**WO 6778955
HVAC Systems @ MWD
Kennels B-4654**

AMENDMENT #02

Amendment 02
WO 6778955, HVAC System @ MWD Kennel, B-4654
MCAS, Cherry Point, NC

NEW WORK FLOOR PLAN
SCALE: 1/4" = 1'-0"

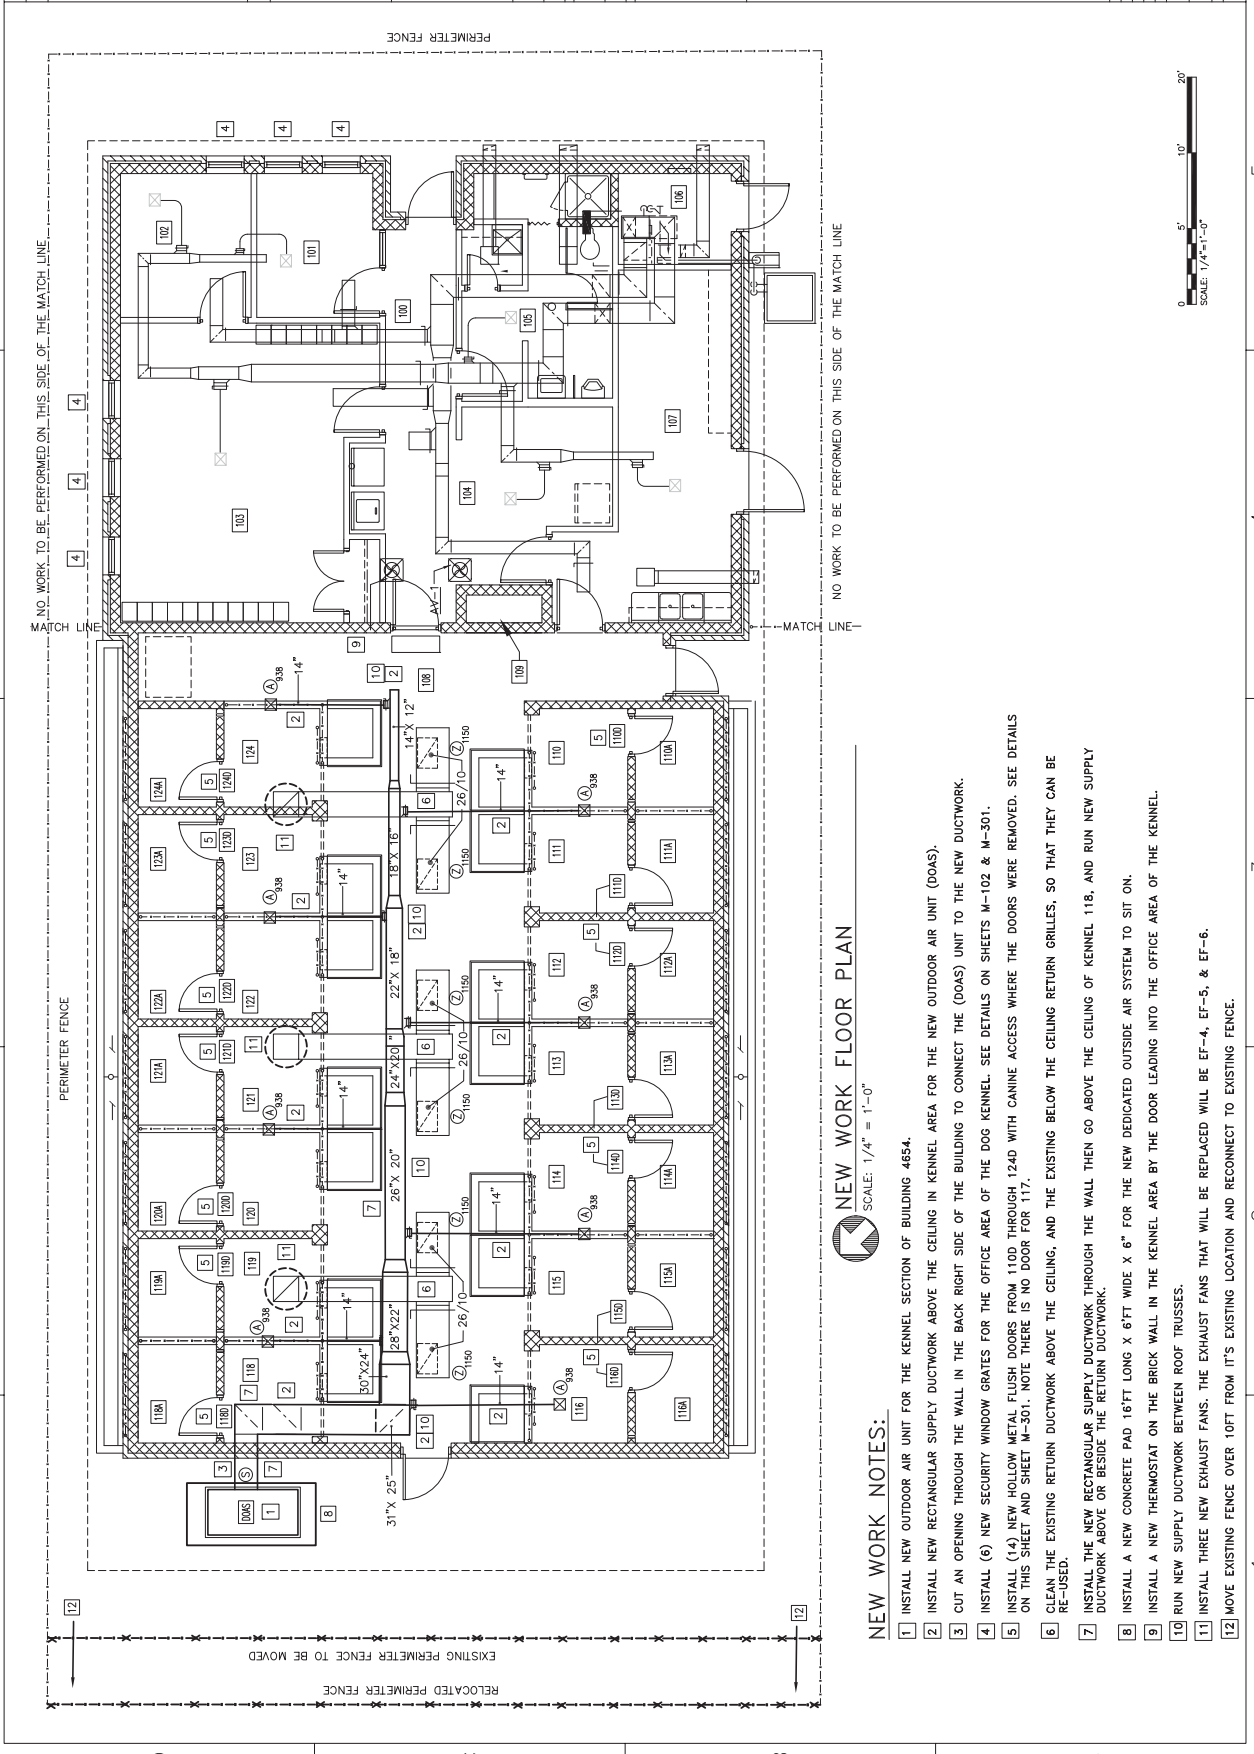
RFI #3: Note #2 on Drawing M-101 indicates all supply ductwork above the ceiling in the Kennel is rectangle. The sizing for this duct is one dimensional, as if the duct is round. Please clarify the sizing of the rectangle supply ductwork above the ceiling in the kennel.

Response: Clarified the sizing of the rectangle supply ductwork above the ceiling in the kennel area on Drawing sheet M-101. Revised Drawing M-101 attached.
